AGENDA
REGULAR MEETING OF THE BIRMINGHAM PLANNING BOARD
WEDNESDAY JANUARY 24, 2024 – 7:30 PM
151 MARTIN ST., CITY COMMISSION ROOM 205, BIRMINGHAM MI *

SUBJECT: 720 S. Adams – Preliminary Site Plan Review ([Updates in Blue](#))

The applicant has submitted an application for Preliminary Site Plan (PSP) review for the construction of a 5-6 story mixed-use building in the B2 (General Business) and MU3/MU5 Zoning Districts. The subject site is located on the corner of Haynes Street and S. Adams with a single story commercial building formerly occupied by “The Plant Station”. The proposed development consists of one parcel with two Triangle Overlay District zones, MU5 on the western 60 feet and the remaining eastern portion being MU3. The subject property is adjacent to the recently approved development for 770 S. Adams (now 707 Worth) on the southern and western side.

SITE PLAN
SCALE: 1/32" = 1'-0"
NORTH

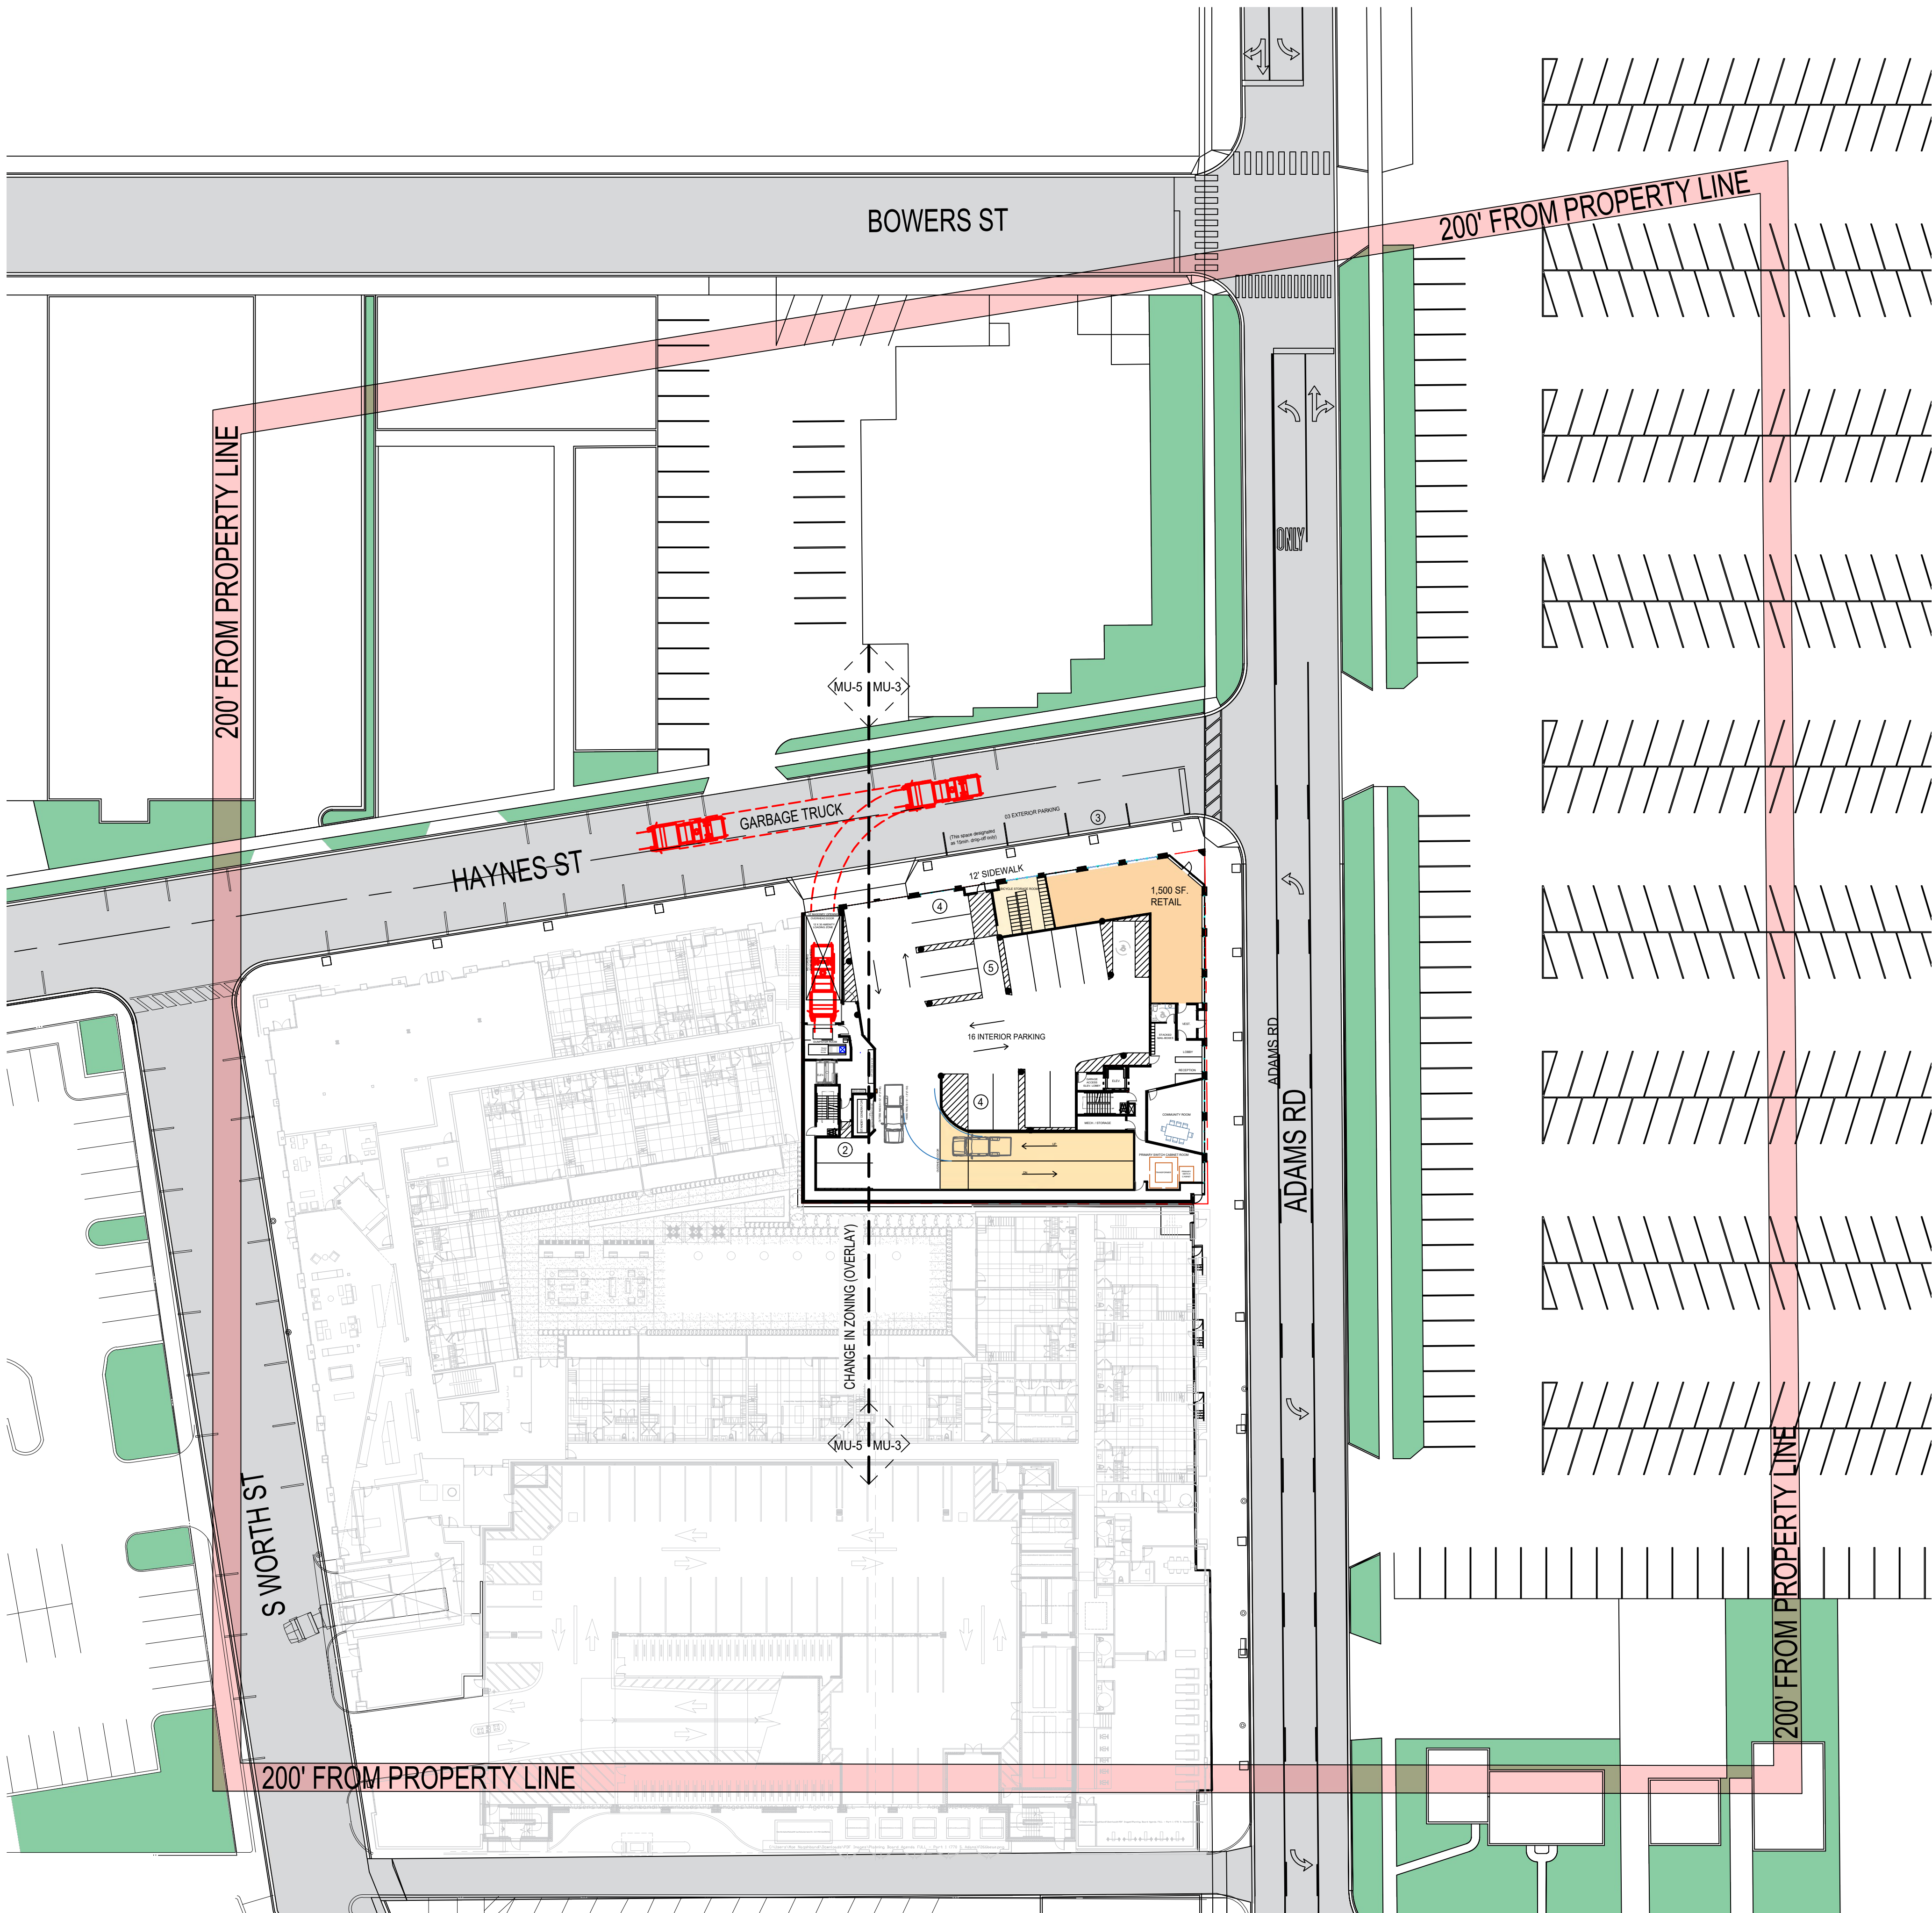
The side setback along the south elevation is 0' for walls that do not contain windows, and 10' for walls that do contain windows. The site plan indicates balconies on the southern elevation that project to the 0' lot line. The site plan indicates glass doors for access to the balconies on the southern elevation that are set back 10' from the lot line and therefore permitted. [The southern balconies face a courtyard of the 707 Worth St. development where the updated site plan indicates first floor windows of the wall along the 0' lot line facing the neighboring courtyard which are not permitted unless the windows are fire rated. The applicant must remove the first floor windows from the southern and western elevation or verify the windows will be fire rated.](#)

- 3.5 Streetscape Elements – The applicant has provided a number of street trees, street lights, and what appears to be 4 benches, 4 trash receptacles, and 6 bike racks on the site plans submitted. In terms of street trees, Article 4, Section 4.20 (G) requires at least 1 street tree for each 40 linear feet of frontage along a street. Details of the tree species will be provided during Final Site Plan review. A breakdown of the required and proposed street trees is provided below:

As far as streetlights, the applicant appears to be proposing 8 street lights total, 4 along Haynes, and 4 along S. Adams. Each streetlight is spaced 40 ft. apart and set in between street trees. All streetlights proposed are expected to meet the streetscape standards for the Triangle District. A full analysis will be conducted at Final Site Plan review.

Finally, the applicant has proposed 4 total benches: 2 along Adams and 2 along Haynes. There are 3 bike racks proposed on Haynes and 3 on S. Adams, and 4 trash receptacles located adjacent to the benches on the site plans submitted.

BASEMENT LEVEL

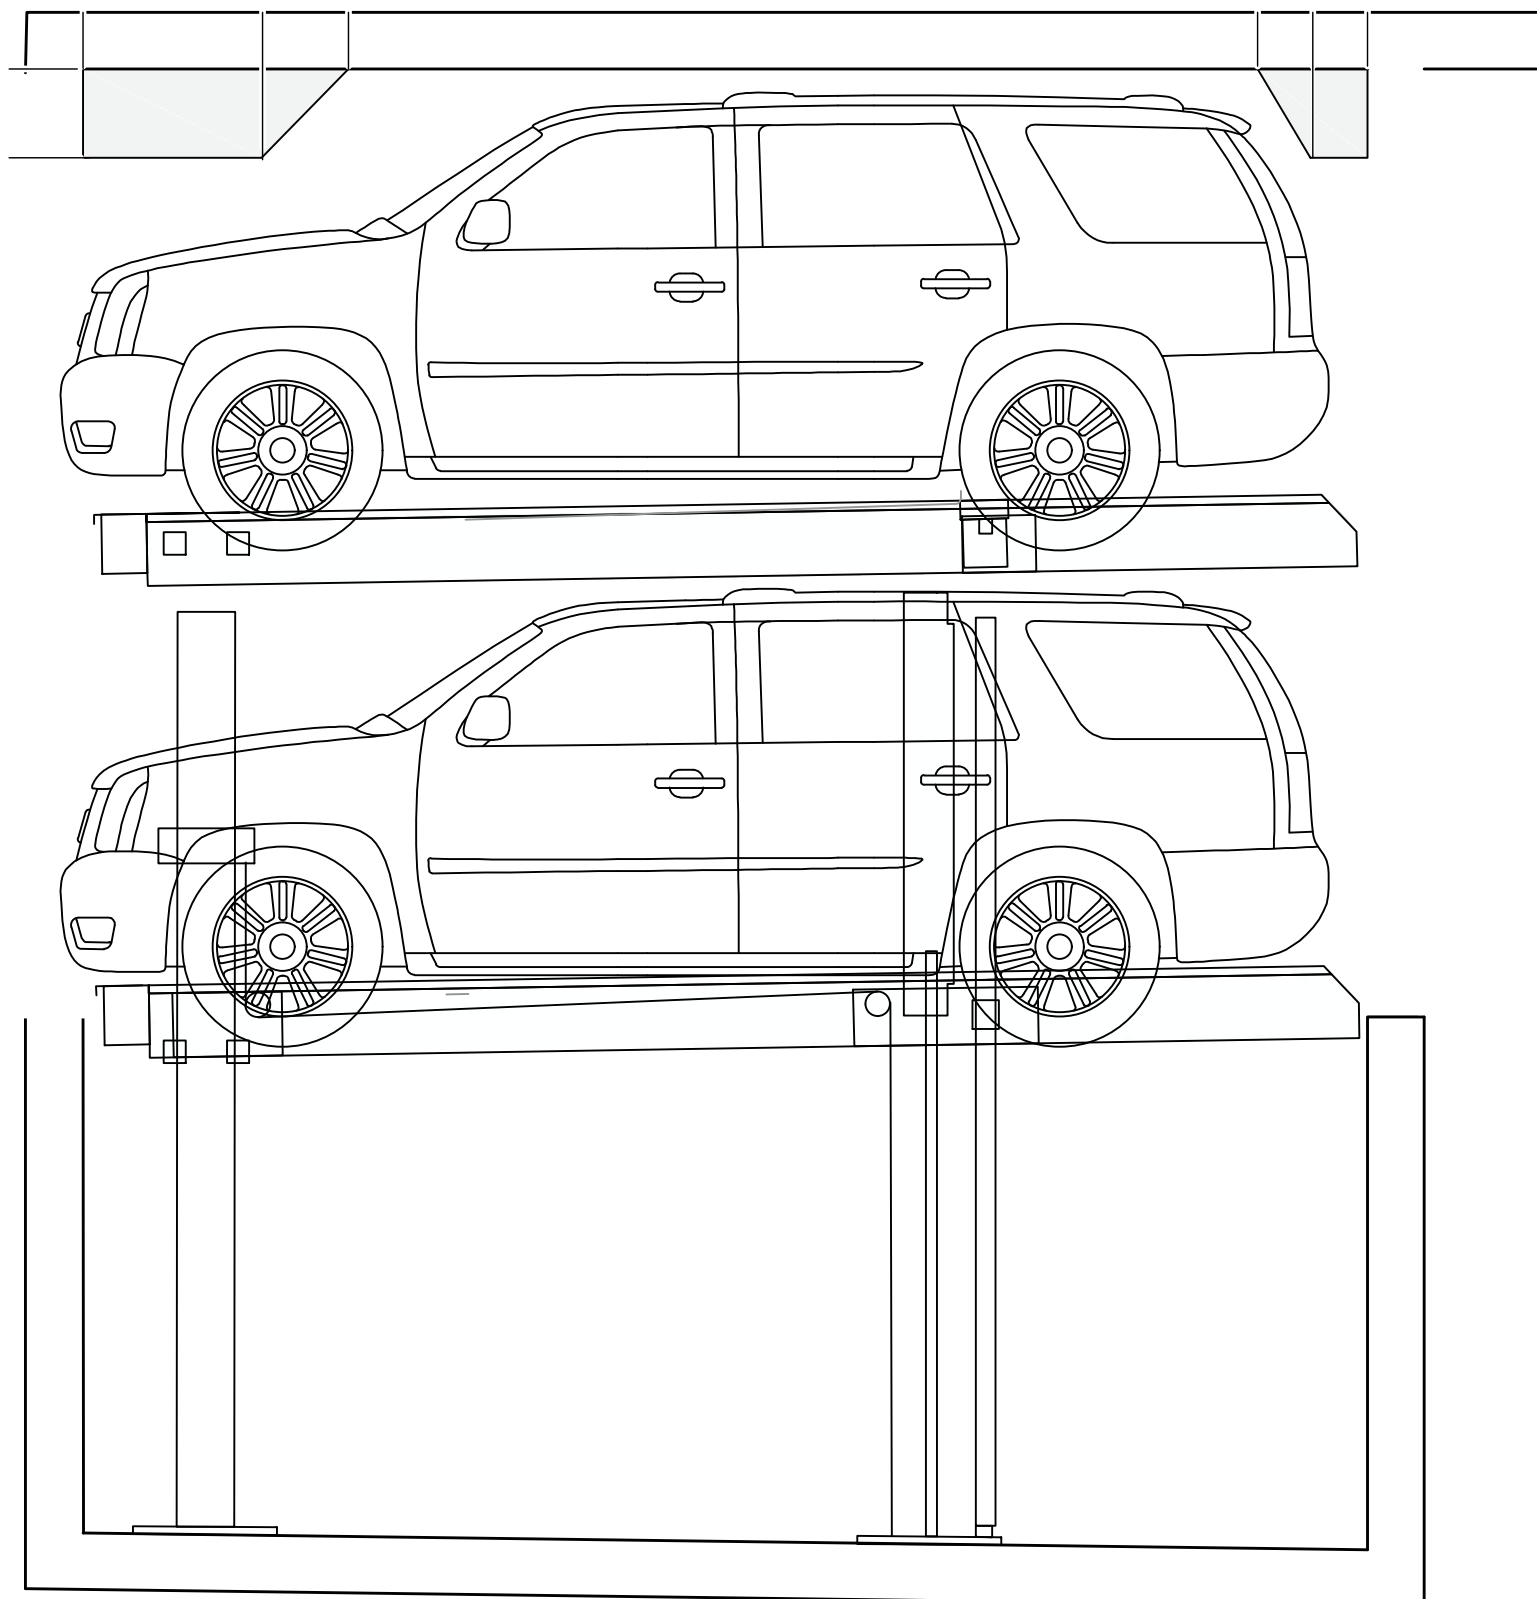
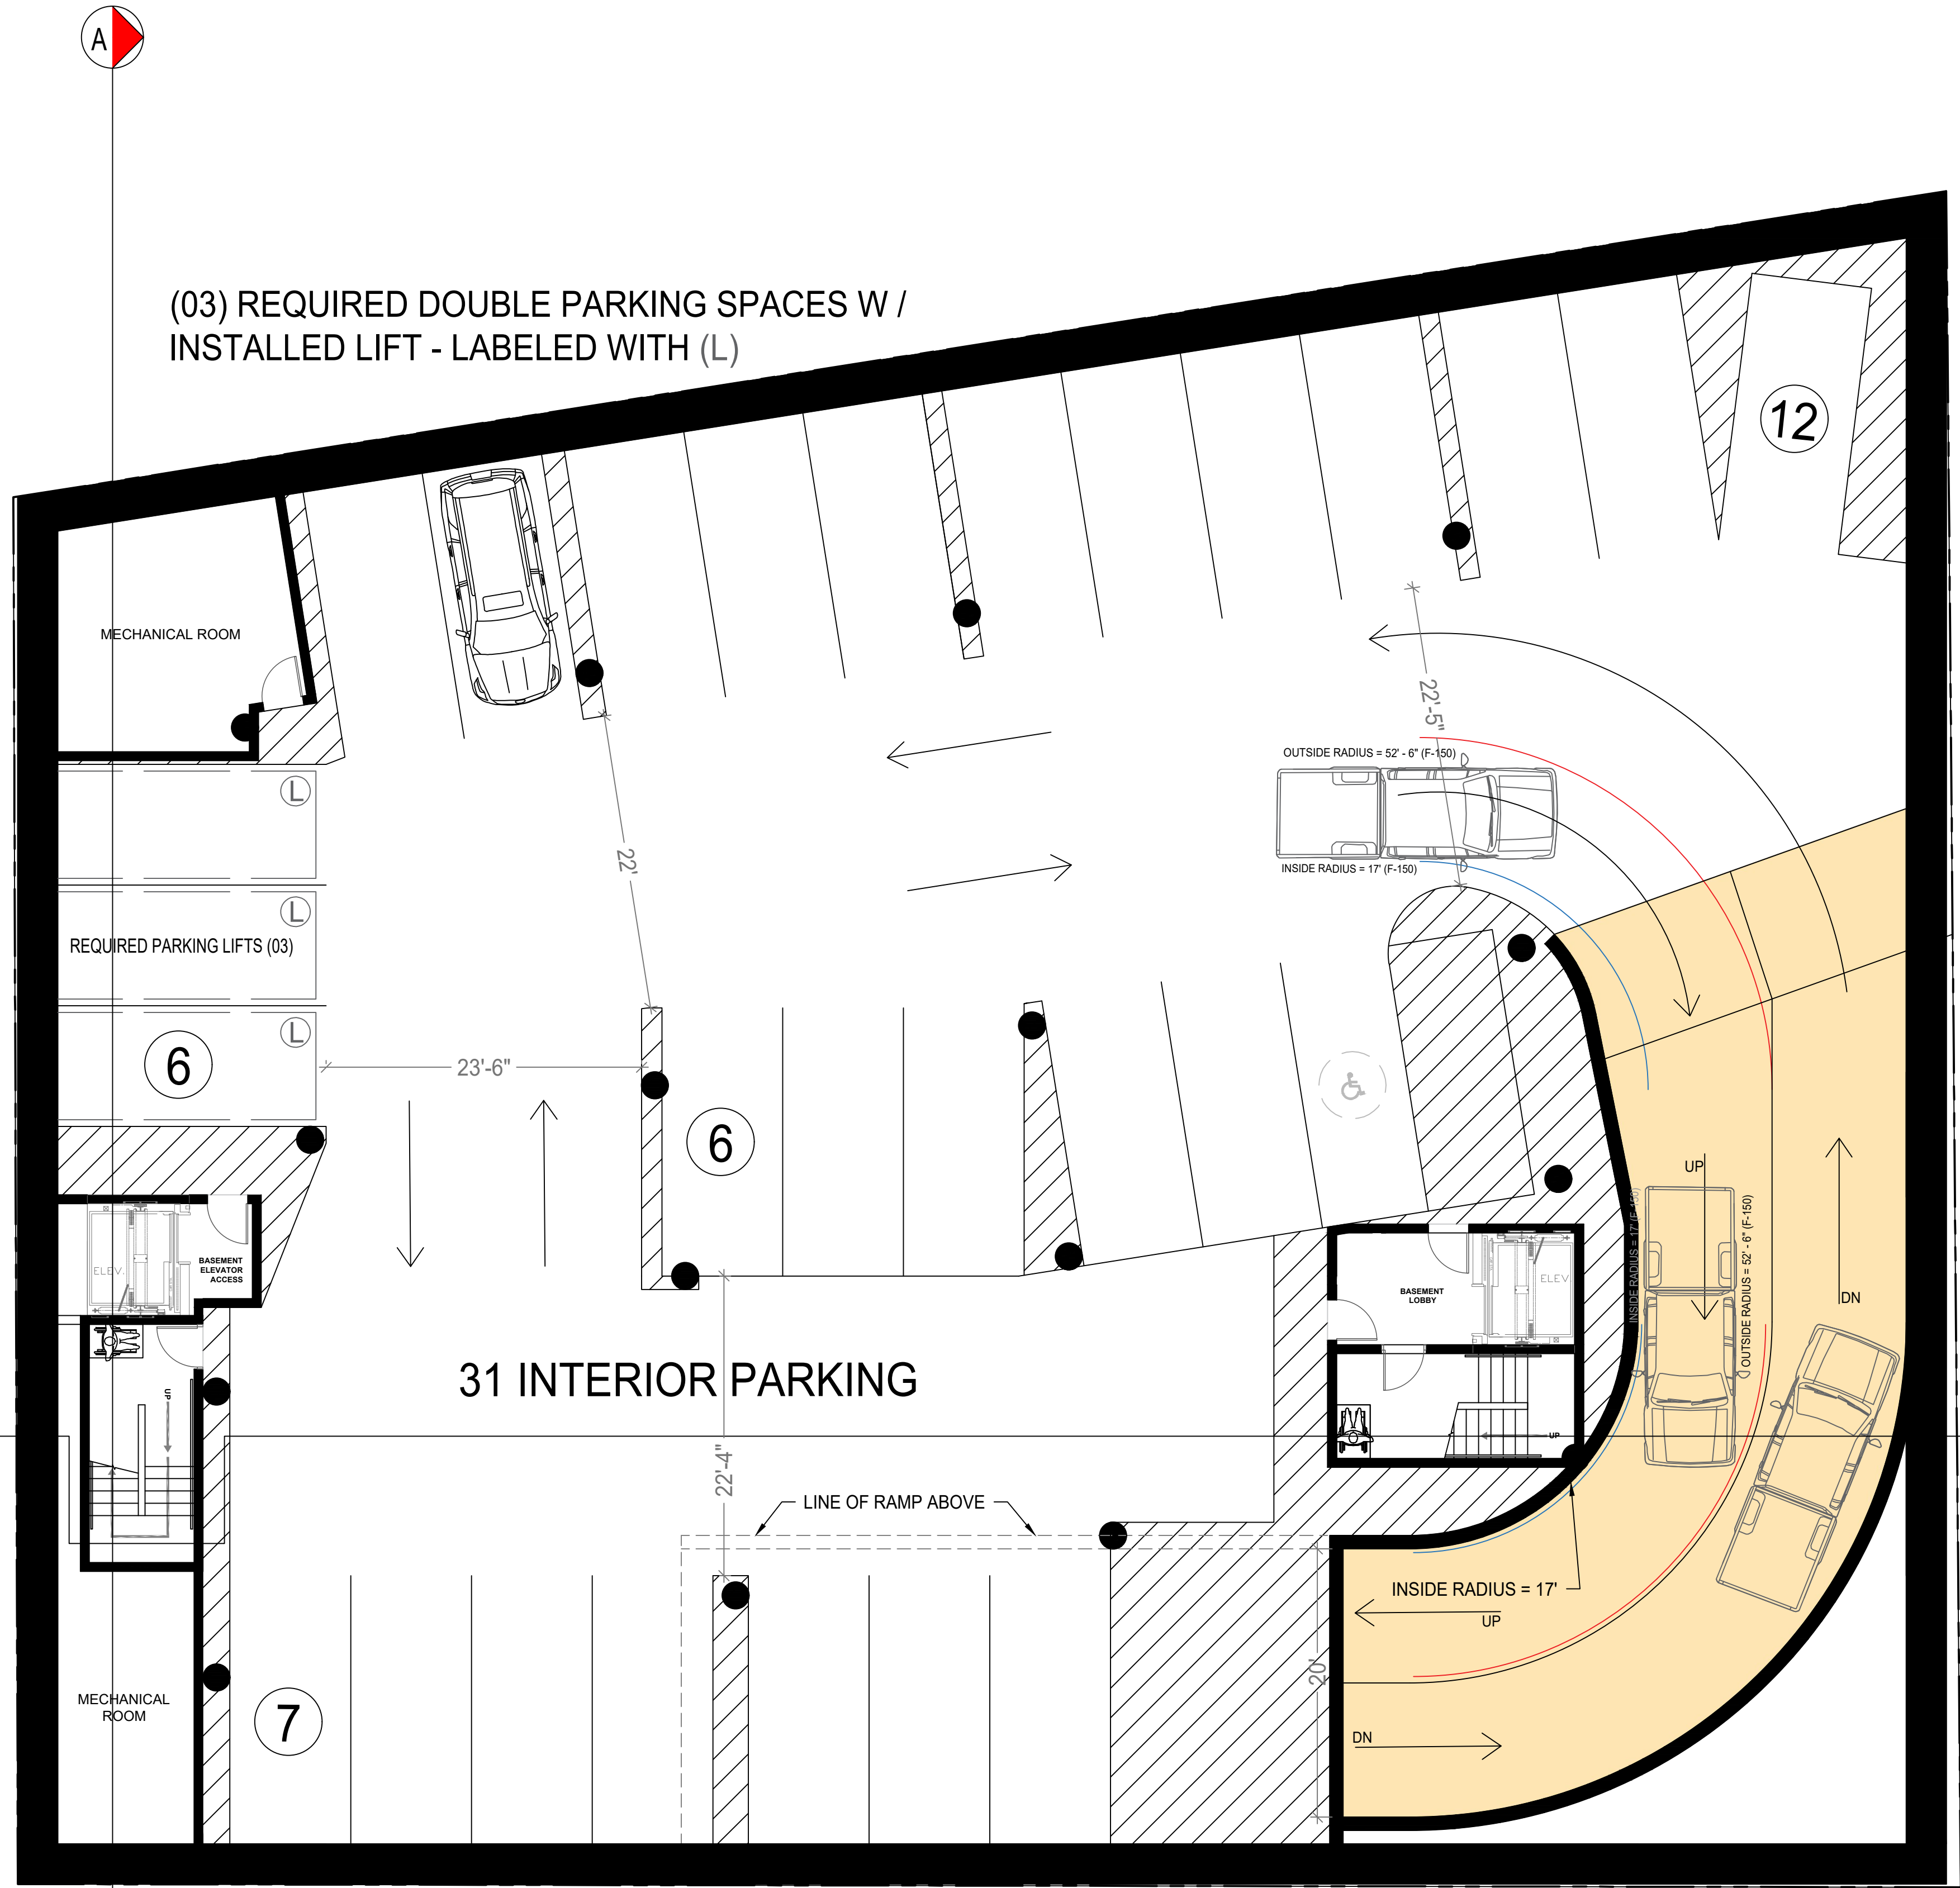
The updated site plan indicates proposed column locations with each parking location dimensions labeled. The updated plans also include turning illustrations for each parking space to indicate the accessibility. There appears to be columns projecting into parking spaces which may impact the access of the parking space. **The applicant must update the parking plan so that parking spaces are not interrupted by building columns.**

The site plan indicates the use of three parking lifts in the lower level parking area along the western portion of the building. The underground parking level has a ceiling height of 13' - 2.5". An illustration of the parking lift is provided on the site plan. If on-site parking spaces have to be adjusted or removed to accommodate column space, staff recommends the applicant include additional parking lifts.

1. The applicant provides a LEED scoresheet for verification of LEED credentials for Final Site Plan review;
2. The applicant adjusts the parking area so that columns do not interfere with access to parking spaces;
3. The applicant satisfy the provisions of Section 3, Article 3.08(E) for additional building height;
4. The applicant submit lighting and material specifications, samples, photometric plan and all other required information for the proposed building to complete the Design Review at Final Site Plan; and
5. The applicant comply with the requests of all City Departments.
